**Liverpool Health and Academic Precinct - Multi Storey Carpark (MSCP)**  
**Consultation with Sydney Trains**

**GEOTECHNICAL ASSESSMENT**  
**PROPOSED NEW MULTI-STOREY CAR PARK**  
**LIVERPOOL HEALTH + ACADEMIC PRECINCT, ELIZABETH STREET, LIVERPOOL, NSW**

**Liverpool Health and Academic Precinct**  
**Impact of Proposed New Carpark on Sydney Trains Assets**

MSCP - GROUND 02

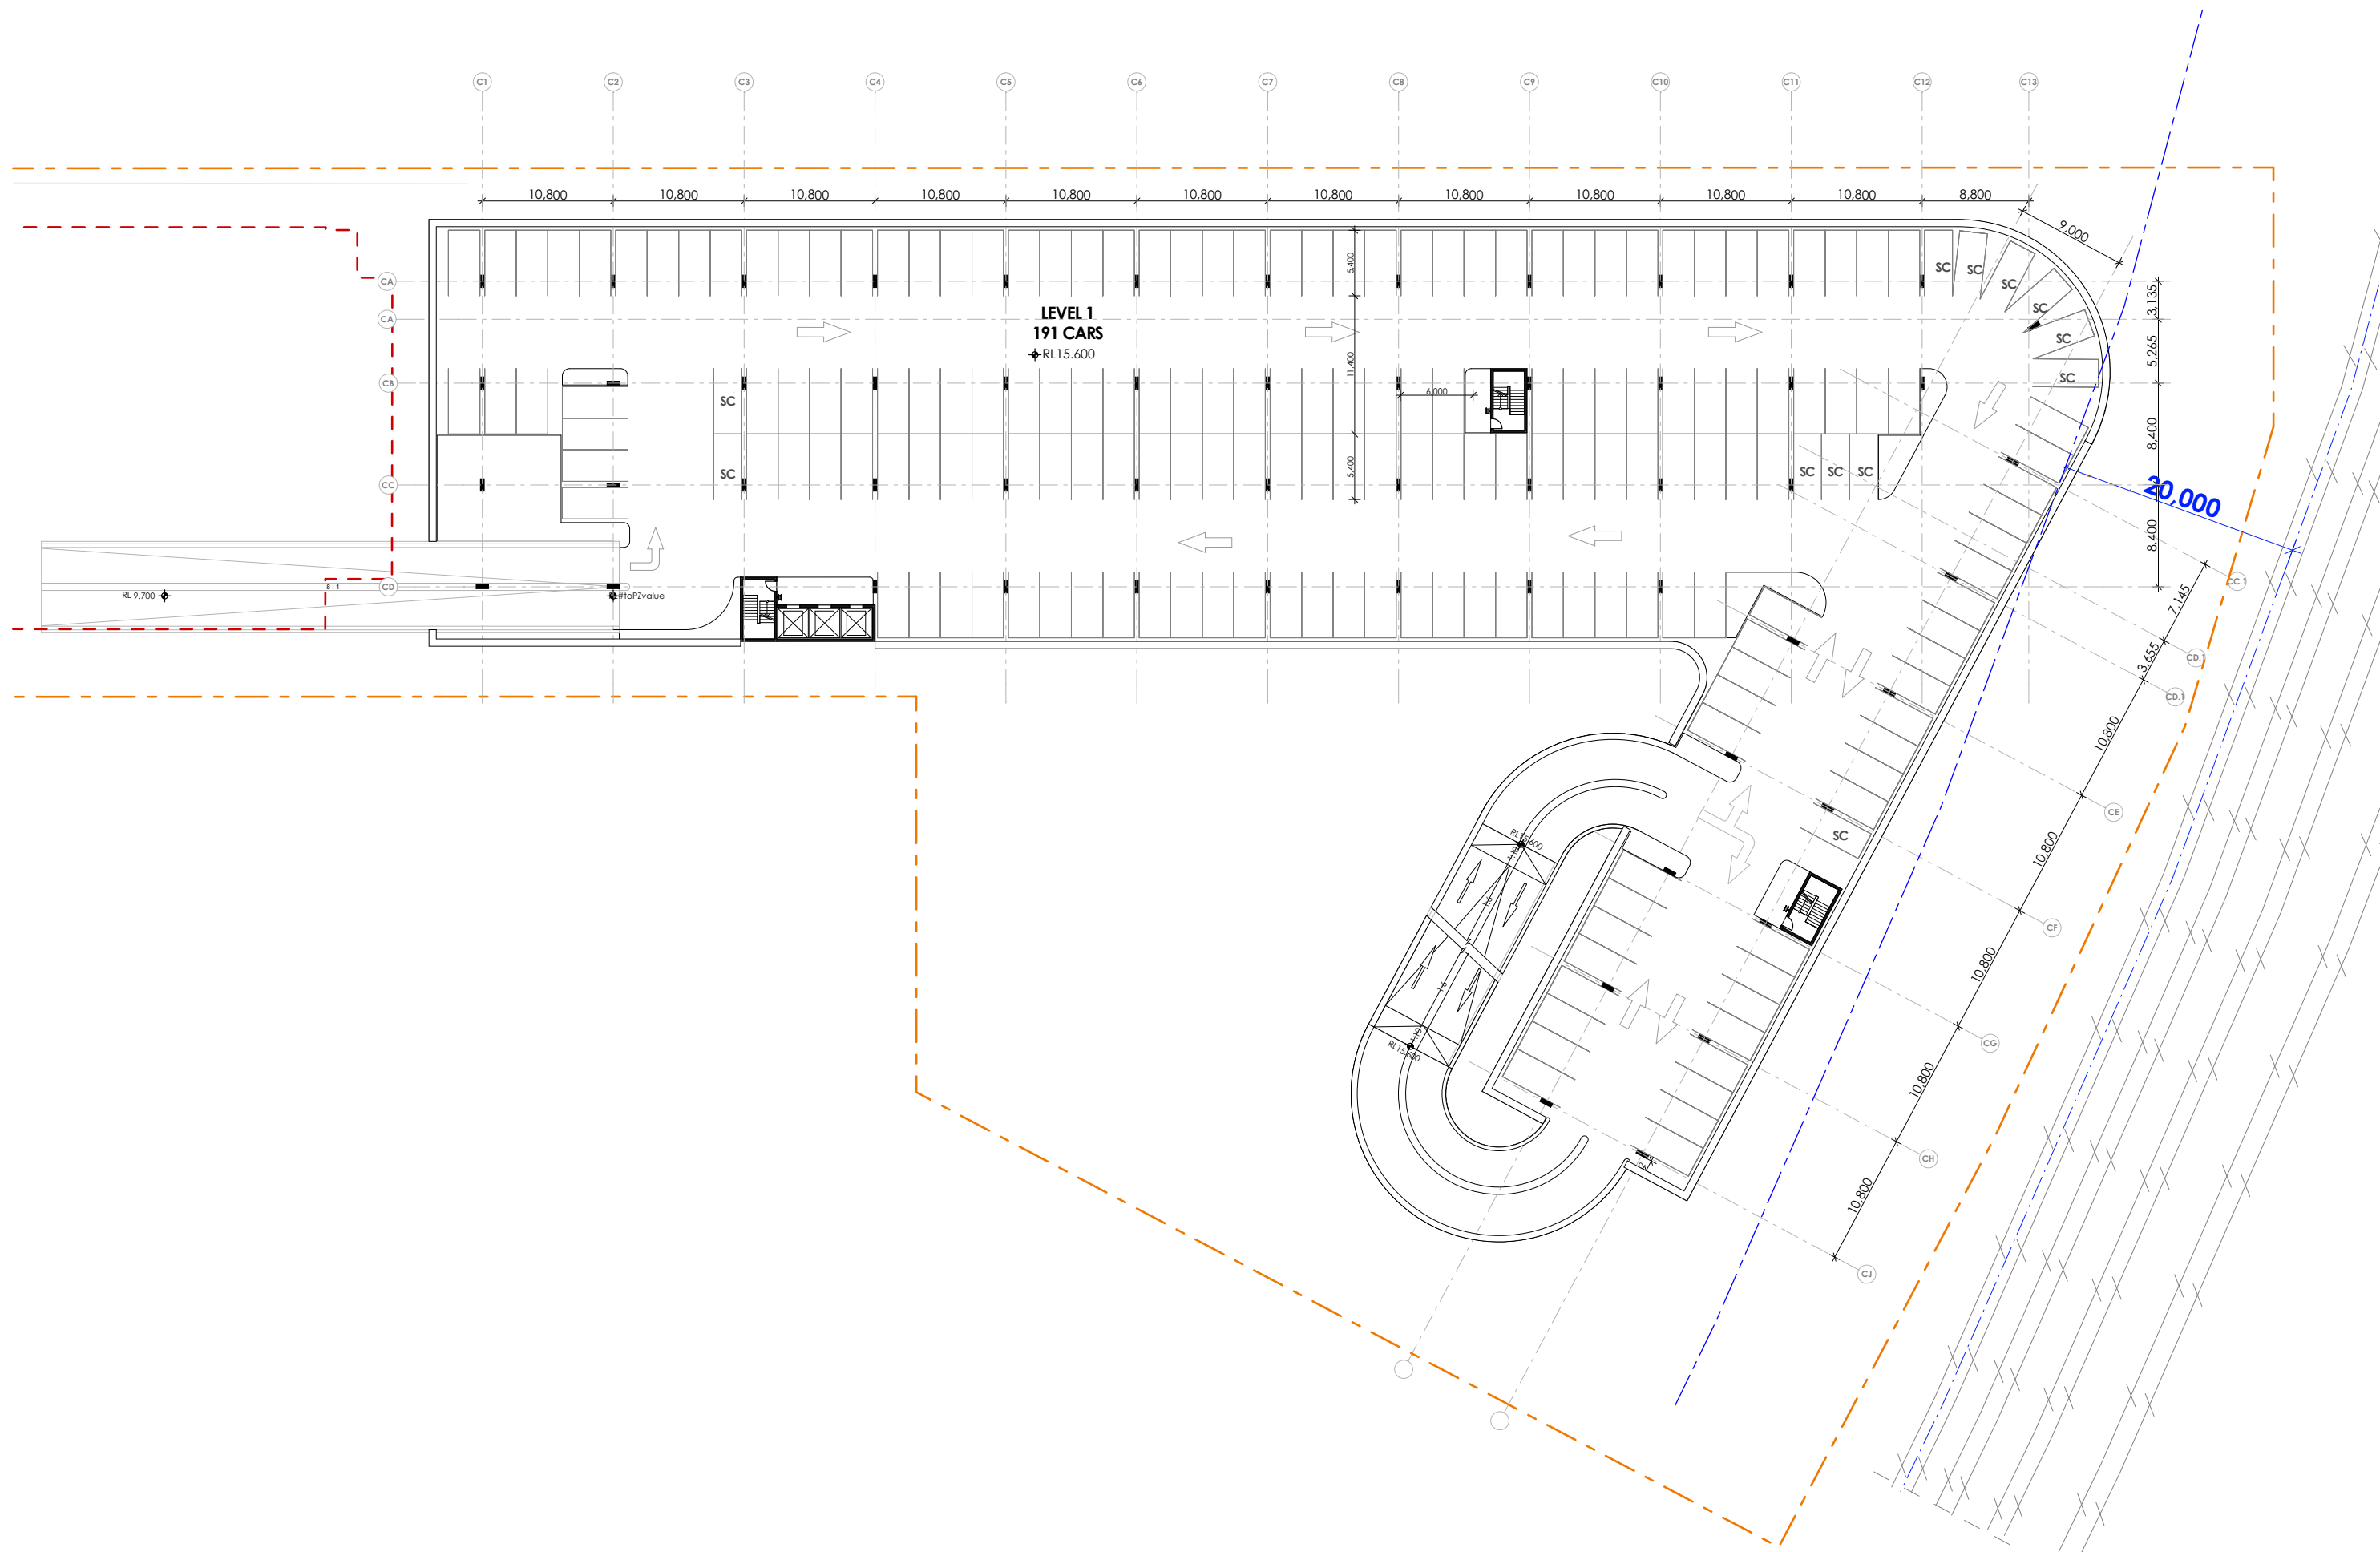
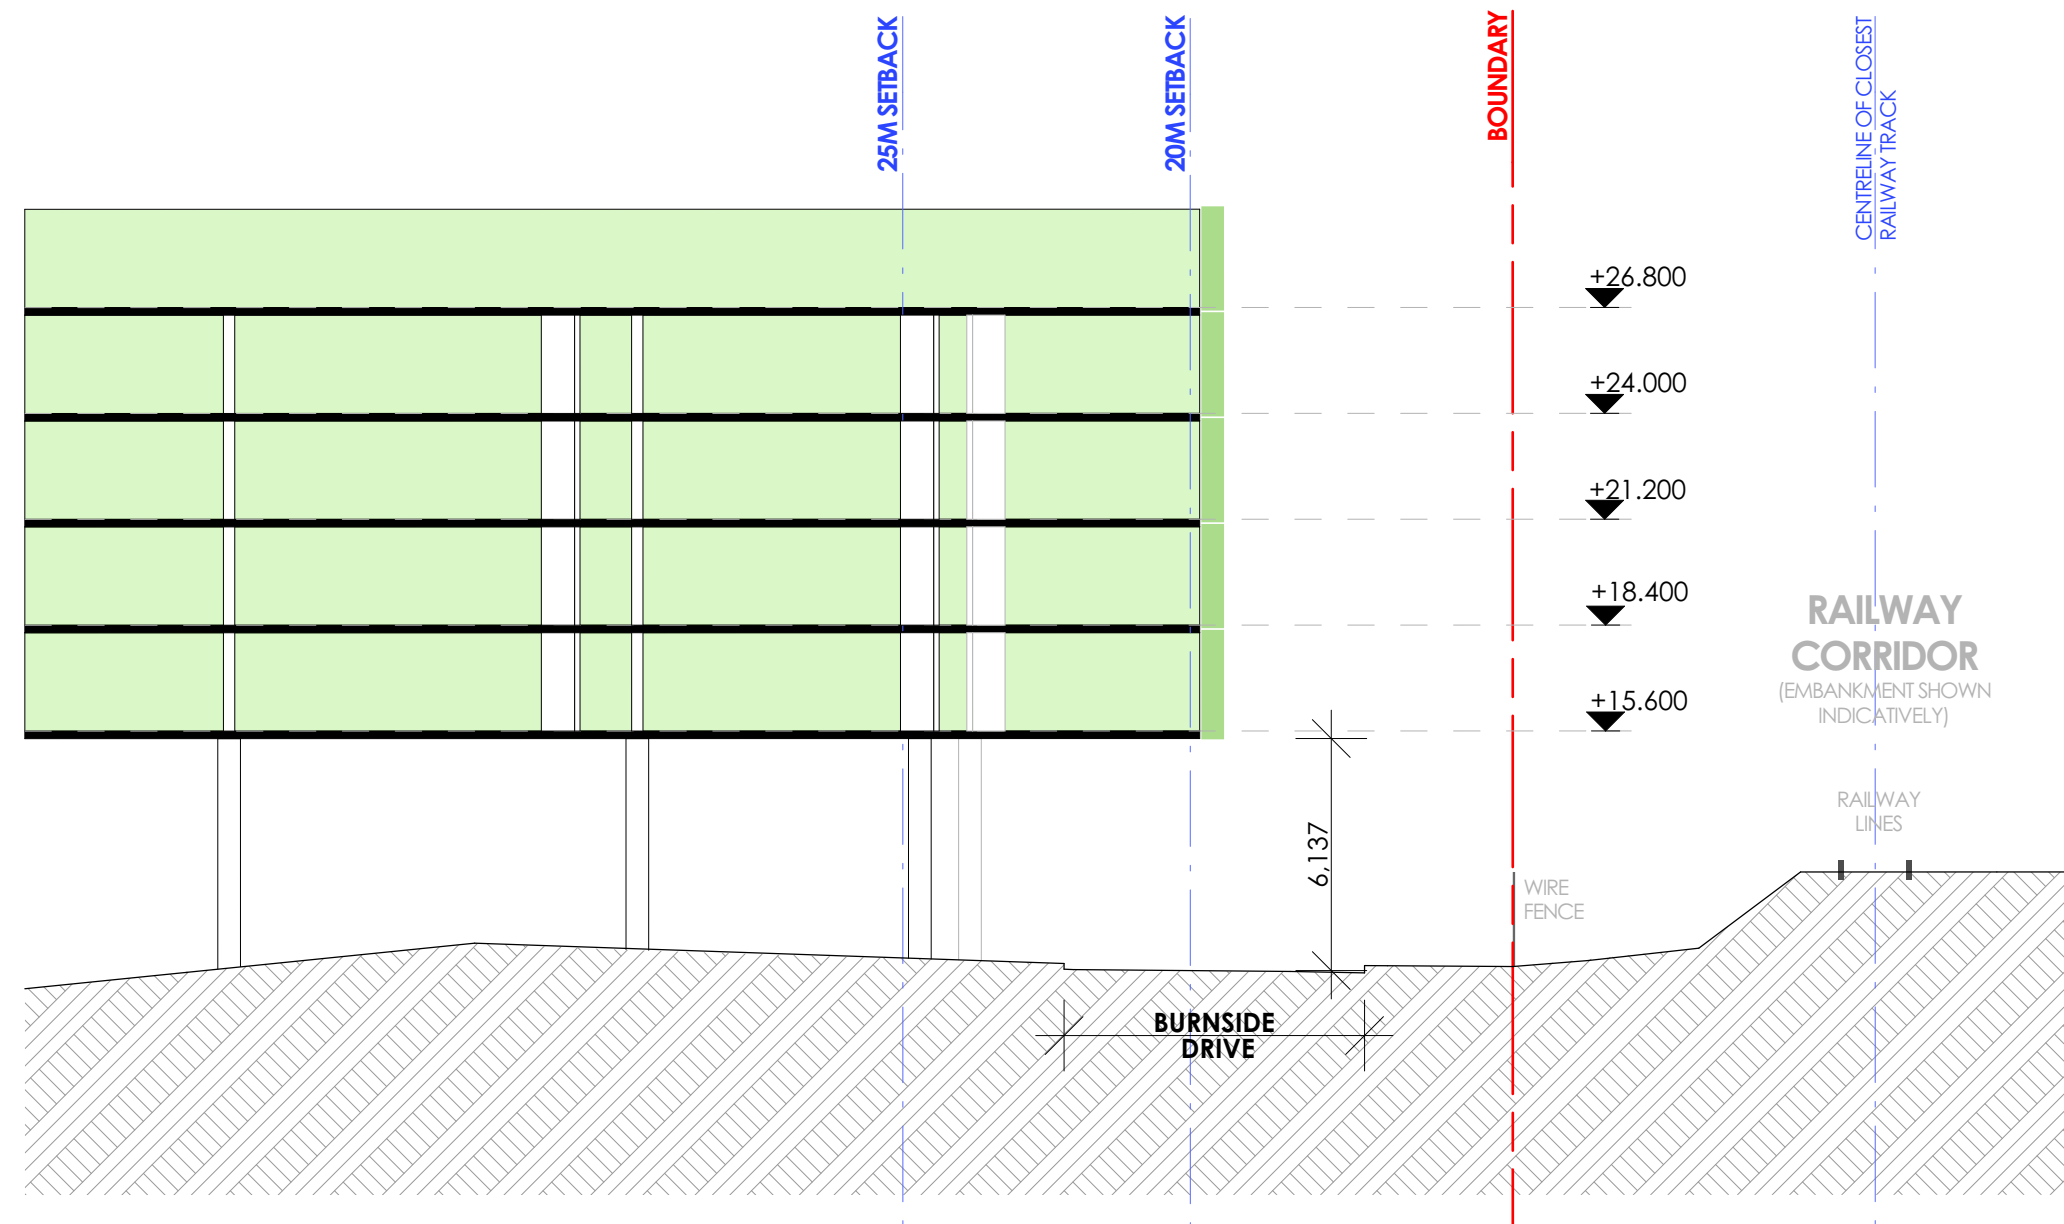
The attached plans show the support structures for the carpark (columns) are all outside of the 20m impact zone. There is a minor intrusion of approximately 1 m into the 20m zone of the suspended floor slab, more than 4m above the ground level at the north east edge of the carpark.

Clause 11.4.3 of AS5100.2 only requires a collision lead for the superstructure within 10m horizontally and 5m vertically of the centerline of the nearest track.

Considering this is a suspended concrete slab, above the level of the railway, we consider the proposed location of the carpark and its support structures do not require a specific design for collision requirements. We request Sydney Trains comment or provide their concurrence with this approach.

It looks ok. You will need to go through the DA process to get a formal review and approval.
